SERVICE BULLETIN

APPLICABILITY: 2018-20MY Crosstrek
2019-20MY Forester

NUMBER: 12-279-20

SUBJECT: Outer Door Handles- Chrome Finish Peeling

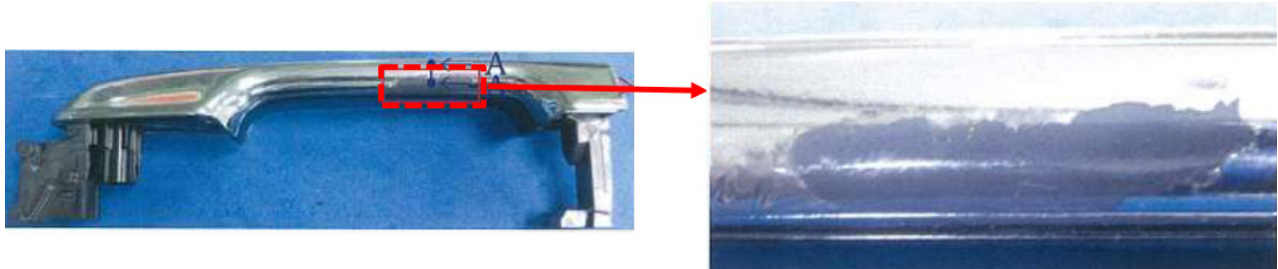
This bulletin announces availability of new outer door handles to address isolated concerns of the chrome finish peeling. Some hand creams and lotions contain oleic acid which may penetrate the chrome finish and cause it to peel as shown in the example photos below. The new handles utilize a plating with increased durability and improved resistance to oleic acid.

The new door handles were incorporated into production starting with the following VINs:

- Crosstrek: **LH214419**
- Forester: **LH455974**

Description	Part Number	Application
HANDLE-DOOR OUTER	61160FL042WW	Front
	61160FL031WW	Rear
